## REMARKS

## IN THE DRAWINGS

Replacement and annotated drawing sheets showing changes to Figs. 1A-1C, 3, 4, 5 and 7 are included as attachments.

FIG. 1A (PRIOR ART)

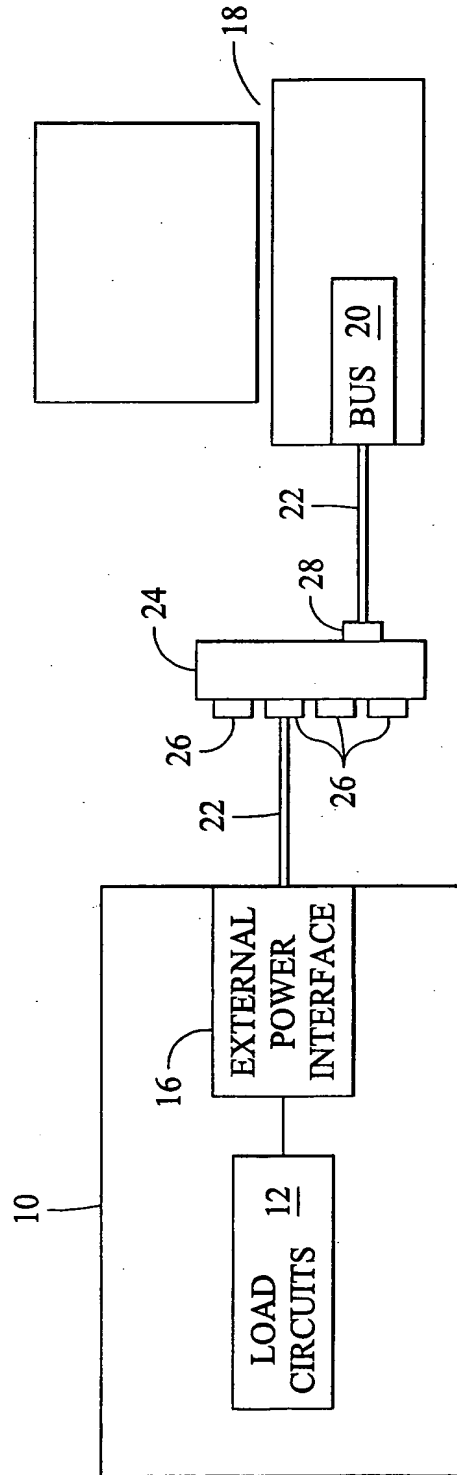
Figs. 1A-1C are revised to include the legend "Prior Art".

FIG. 1C (PRIOR ART)

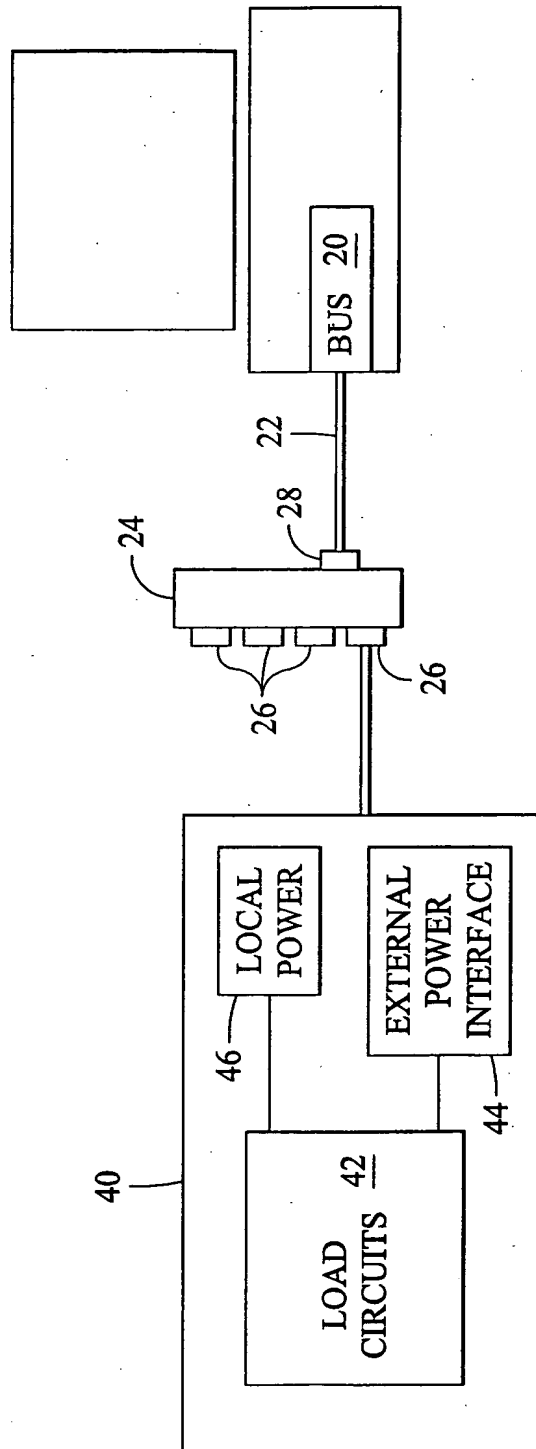
Fig. 1C is revised to include reference designator 18.

FIG. 3

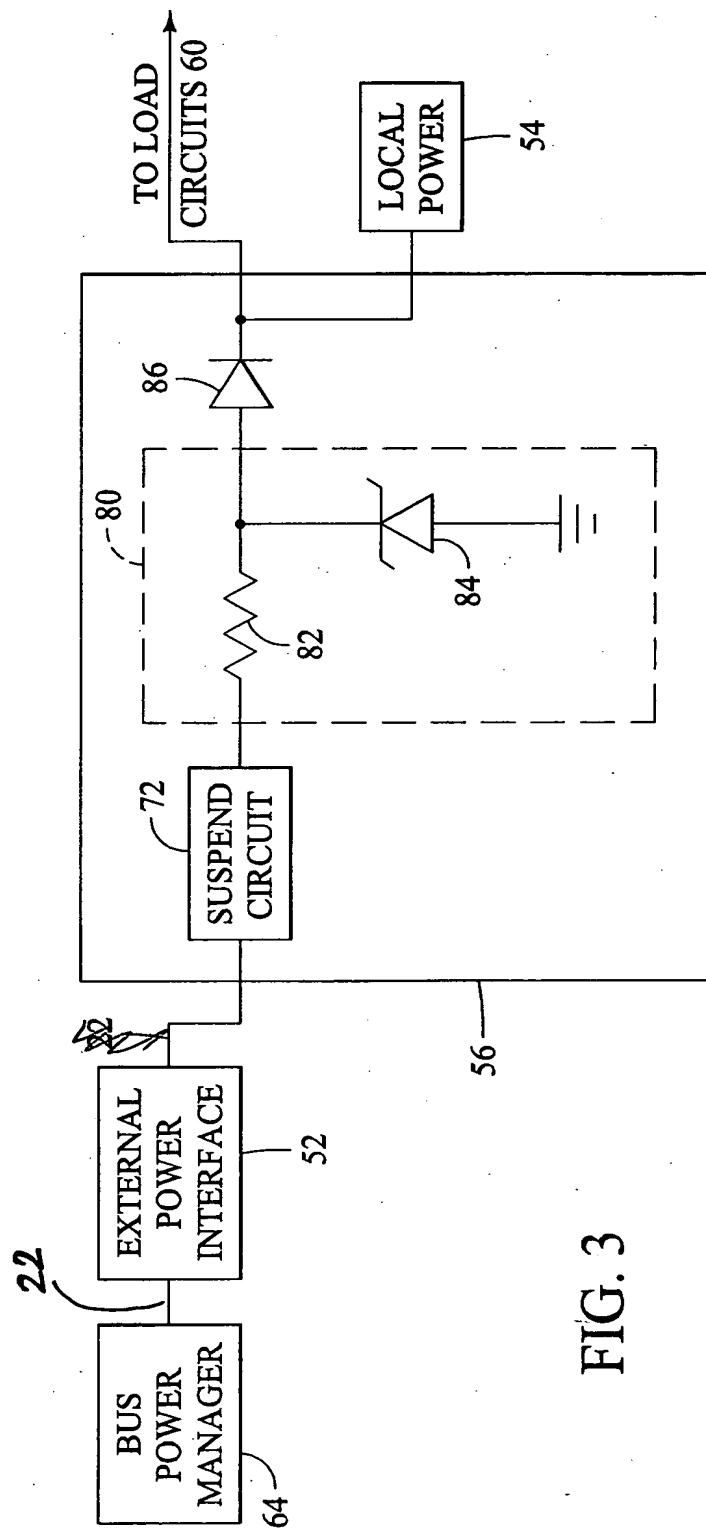
Fig. 3 is corrected to change the location of reference designator 22.

FIG. 4

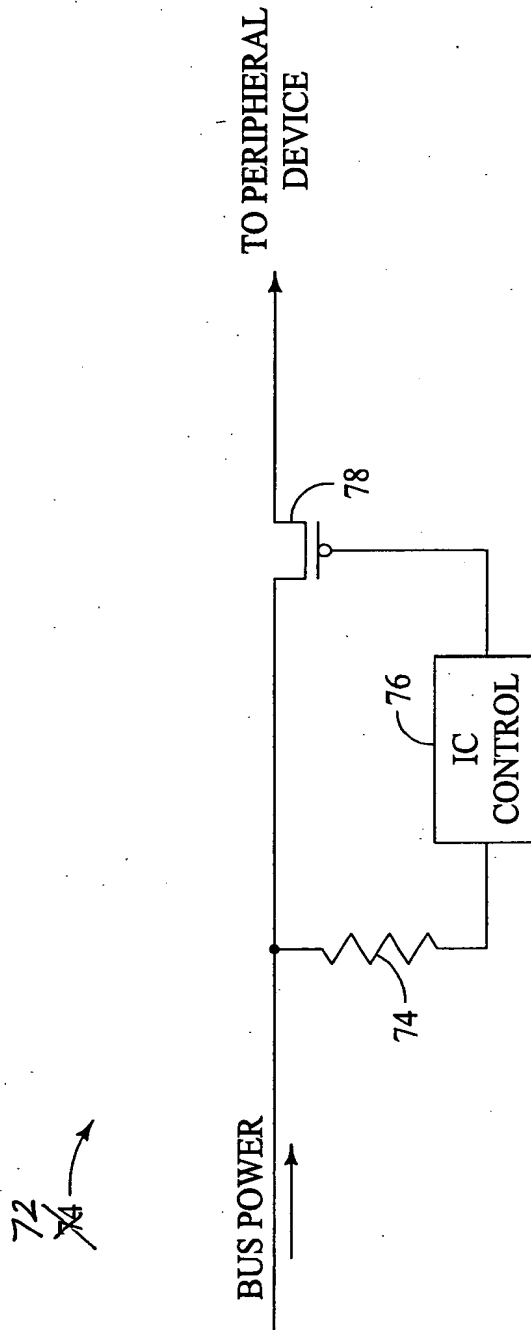
Figs. 4 and 7 are corrected to change the reference designator for the suspend circuit from 74 to 72.

FIG. 5

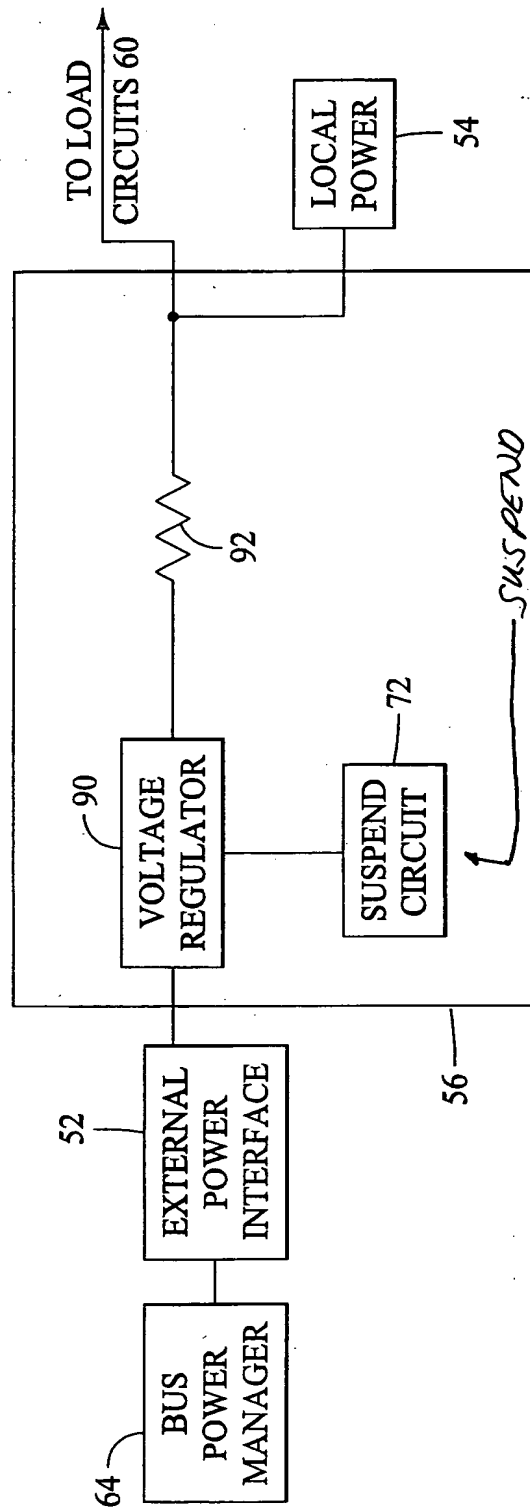
Figs. 5 and 7 are revised to show an input signal to the suspend circuit. Support for this revision can be found throughout the specification, for example, at page 6, lines 15-18.
